RESPONSE TO NRC LTR DTD 02/23/78... FORWARDING ADDL INFO OF REPT NEDM-20988,
"CAORSO RELIEF VALVE LOAD TESTS - TEXT PLANT" WHICH WAS SUBMITTED BY GE ON
BEHALF OF THE MARK II OWNERS GROUP.

SUBJECT: MARK II CONTAINMENT REQUEST FOR ADDITIONAL INFORMATION

RESPONSE TO NRC COMMENTS OF JULY 7, 1977 AND FEBRUARY 23, 1978
ON CAORSO TEST PLAN

FIG. 5-2A PIPE AND QUENCHER TEMPERATURE SENSORS

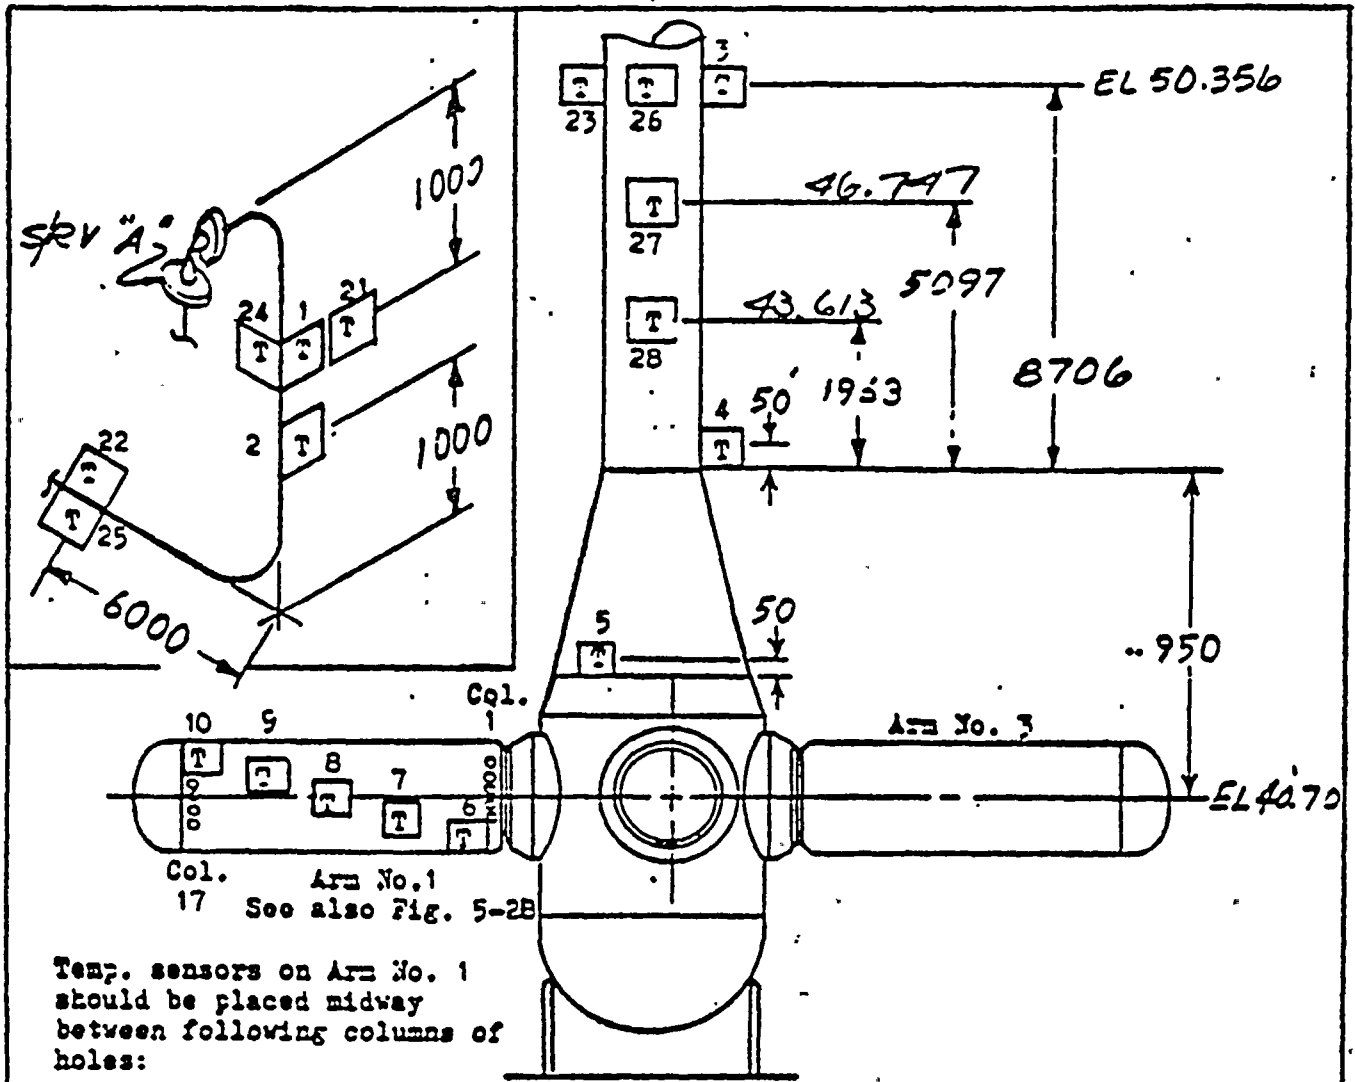
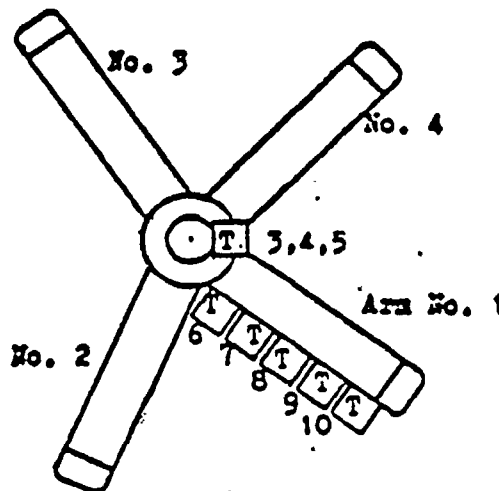
Page 4-6 states that a complete understanding of the subsequent actuation effect requires data on pool temperature in the vicinity of the quencher, pipe temperature and pressure following valve closure, flow rate of air through the vacuum breaker and dynamics of back flow of water. We agree that the air temperature history inside the pipe could be important. However, insufficient information has been given in the test plan regarding the measurement of air temperature in the pipe. Clarify what measurements or calculations will be made to monitor this temperature.

The temperature history of the saturated air-steam mixture inside the SRV discharge line will be measured using sensors T1, T2, T3, and T27 (See attachment (2)). These sensors are designed to measure the temperature of the environment in the discharge line, not the temperature of the discharge line wall. The temperature of the saturated air-steam mixture can be verified using the methods described below.

For the first actuation, the saturated air-steam mixture temperature can be approximated as being equal to the temperature of the discharge pipe inner wall. This temperature will be measured on sensors T24, T25, and T26 (see attachment (2)). For sequential actuations, the air mass will be measured as it enters the discharge line through the vacuum breaker. Given this measured air mass, the discharge line pressure and the total discharge line air-steam mixture volume at the end of the water reflood transient, the temperature of the gas mixture can be calculated using the ideal gas laws by assuming that the steam in the mixture is at saturation corresponding to the discharge line pressure.

FIG. 5-5A POOL PRESSURE SENSORS

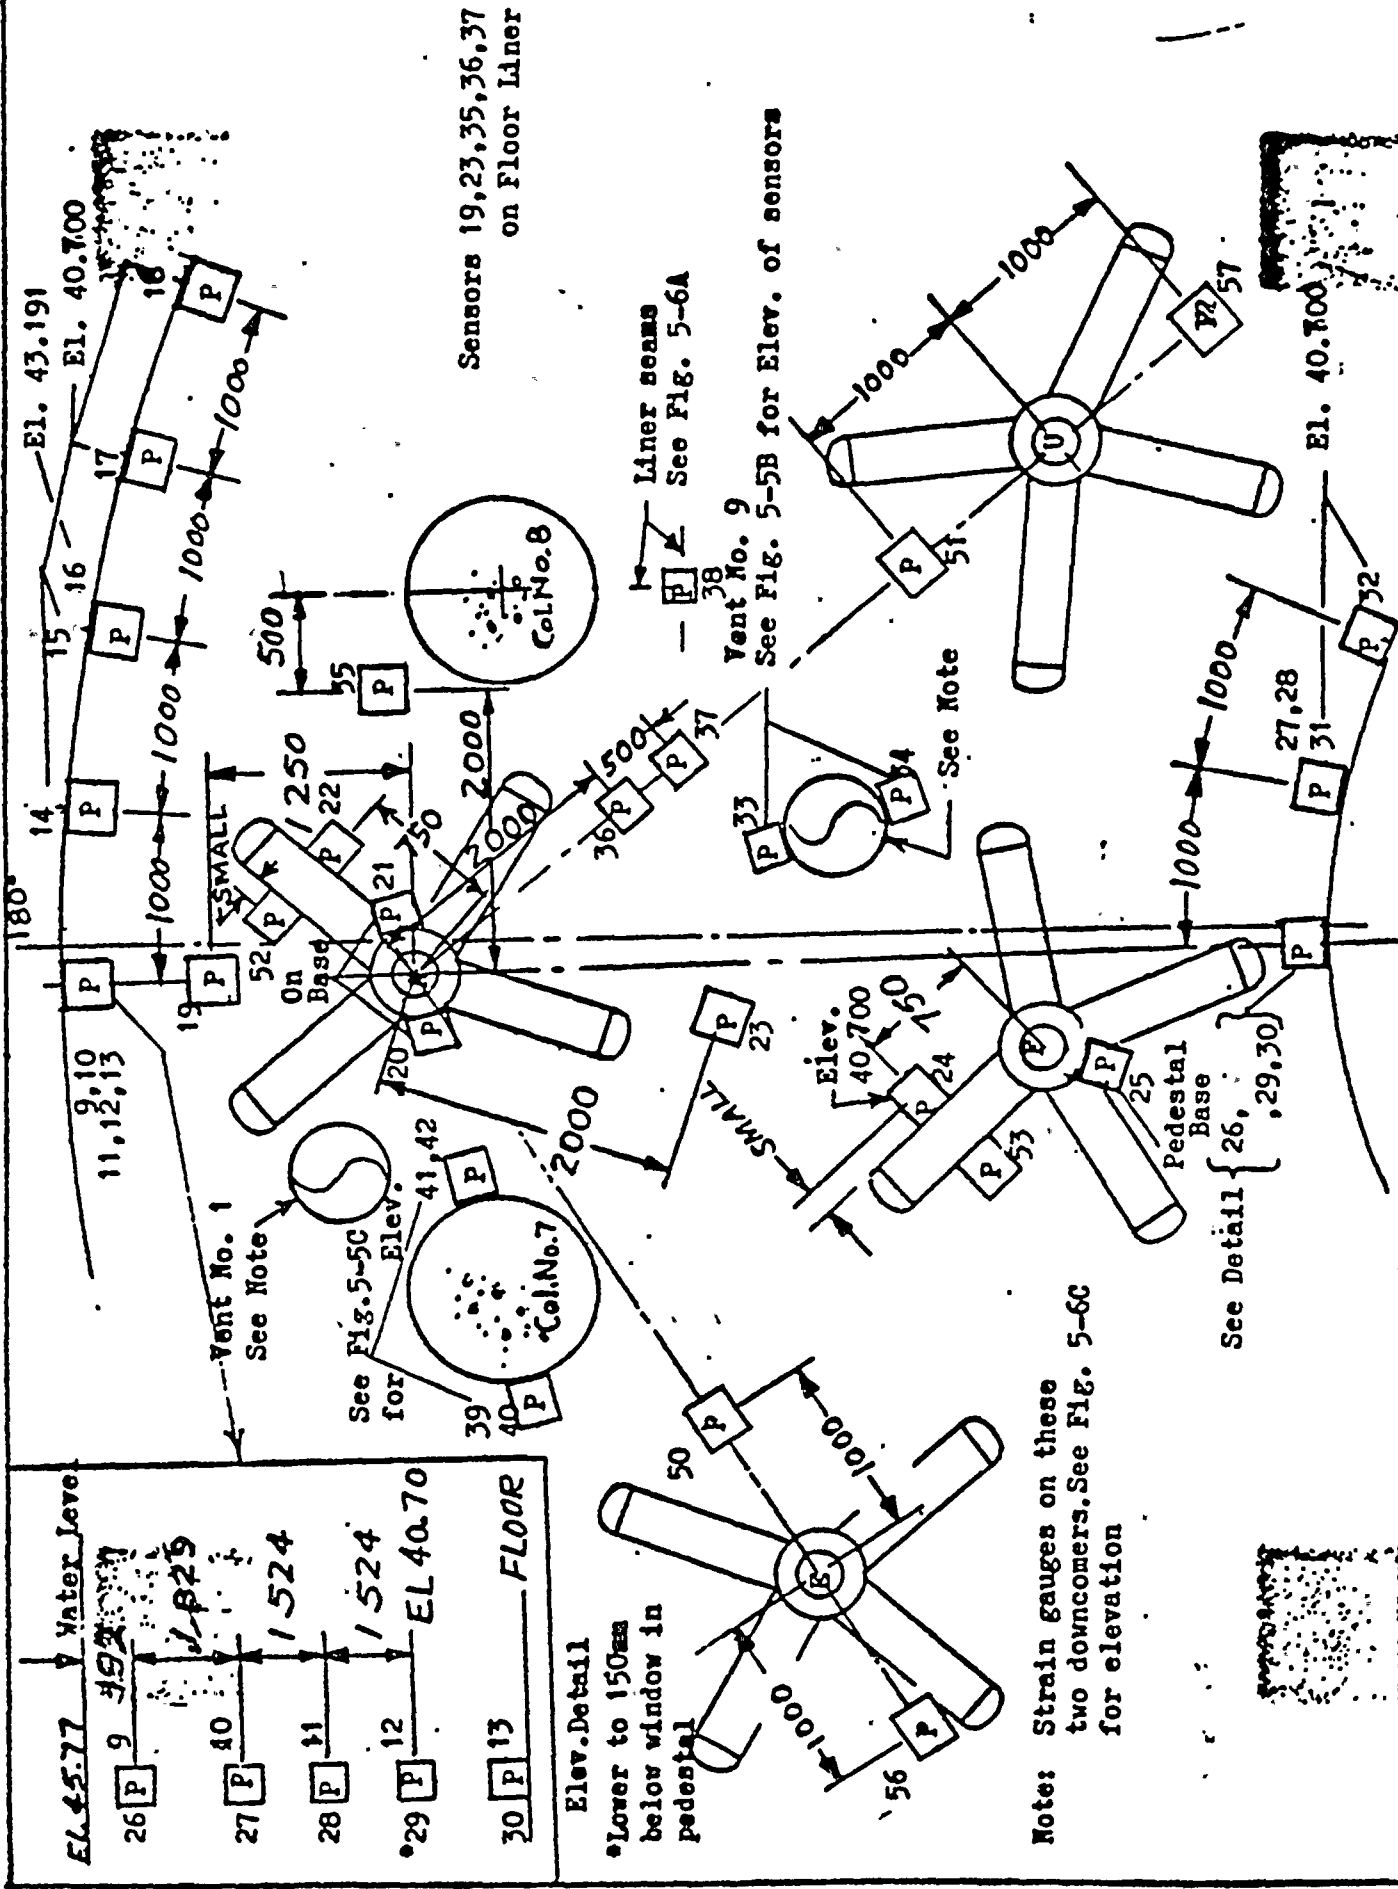
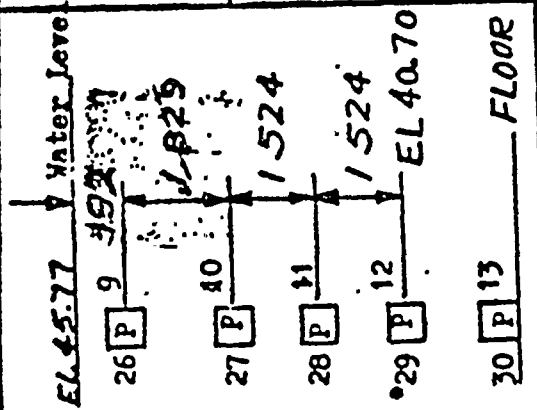
Provide the locations for pressure sensors Nos. 19, 23, 35, 36, and 37.

(a) Slight rearrangement of instrumentation in the suppression pool was accomplished since the issue of revision 2 to the Caorso test plan (NEDM-20988) dated December 1976. Specifically, pressure transducers P36 and P37 were shifted from their original locations near support column 8 to the positions shown on attachment (3). While this shift does not represent a direct backup for sensors P23 and P38, data from these sensors will be sufficient to allow evaluation of multiple valve pop loads should either P23 or P38 fail. At the same time, should sensors P23 and P38 remain intact, sensors P36 and P38 will provide additional useful data which would not be exact duplicates of readings from P23 and P38.

The locations of these sensors are shown in attachment (3).

NEDM-20988 REVISION 2
 FIG. 5-3A LEVEL SENSORS

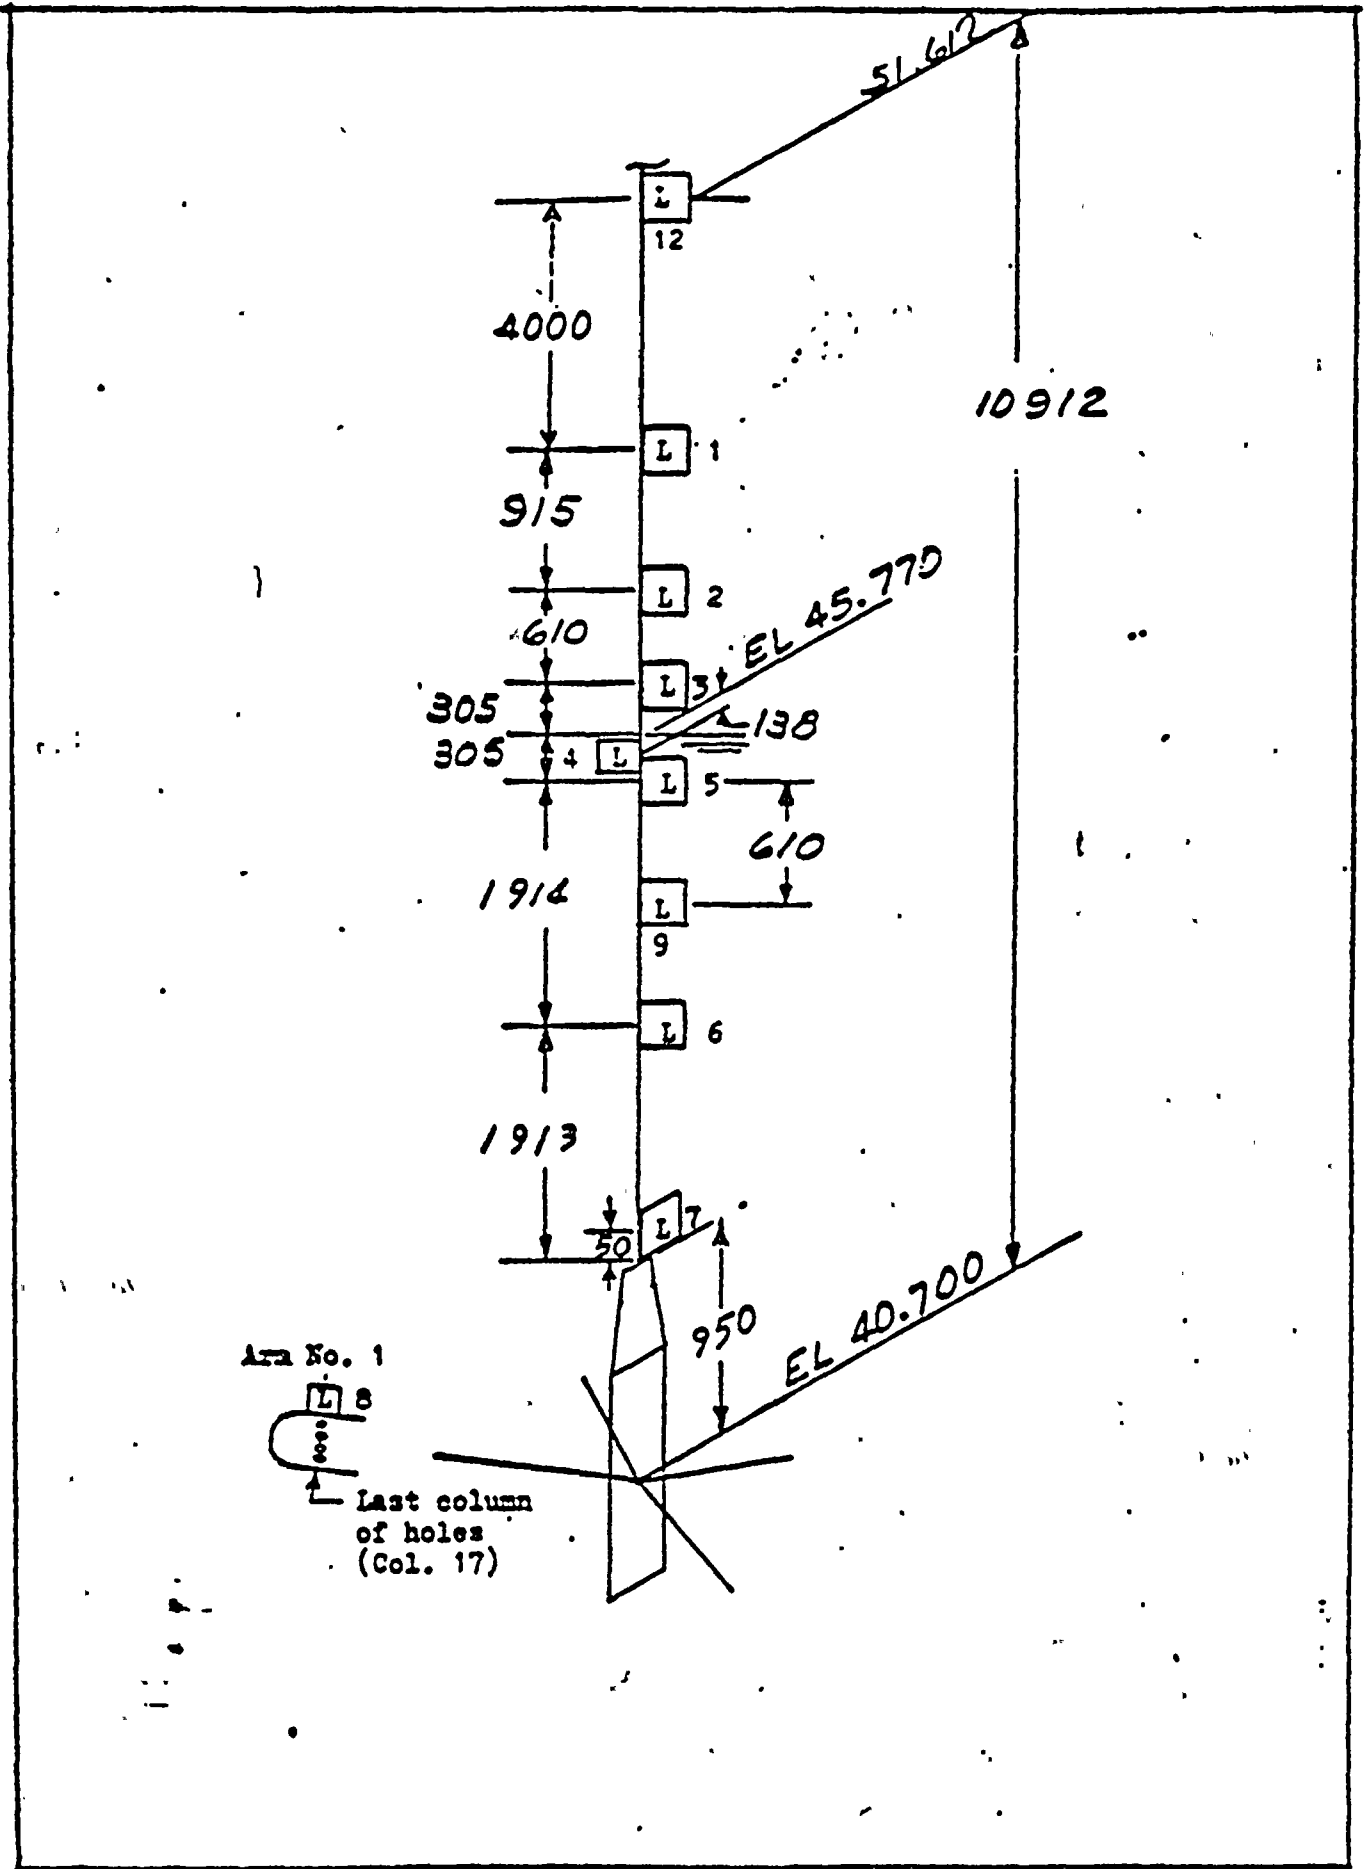
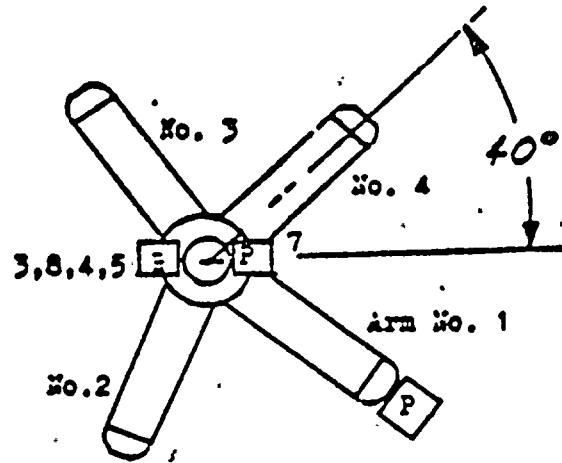
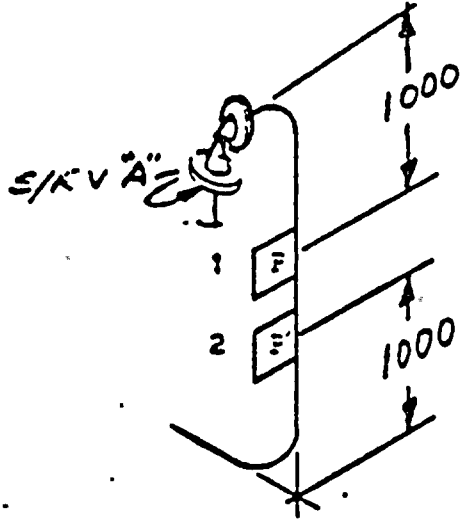
- a. The vicinity of Quencher A and the place by which combined loads from multiple SRV's actuation will be determined.
- b. SRV line between elevation 51.612 and 45.770. In addition, level probes should be added between L1 and L21.

(b) The spacing of level probes L1 and L12 is considered to be of minor importance for the following reasons:

- (1) Licensee data and GE models indicate that the water column will not rise to sensor L1 during the normal vacuum breaker tests.
- (2) The large number of level probes between sensors L1 and L7 allow an evaluation of the velocity and acceleration of the water column; this information, in turn, can be used to determine approximately the maximum level to which the water column rises during the reflood transient.

- (3) Temperature sensor T3 (see attachment (2)) can be used to provide additional water level information between sensors L1 and L12 if required.

With regard to the question of redundancy for level probes between elevations 51.612 and 45.770, temperature sensors T3, T4, T5, T27, and T28 can function as level sensors if required and will provide redundancy for the level probes in case of failure.
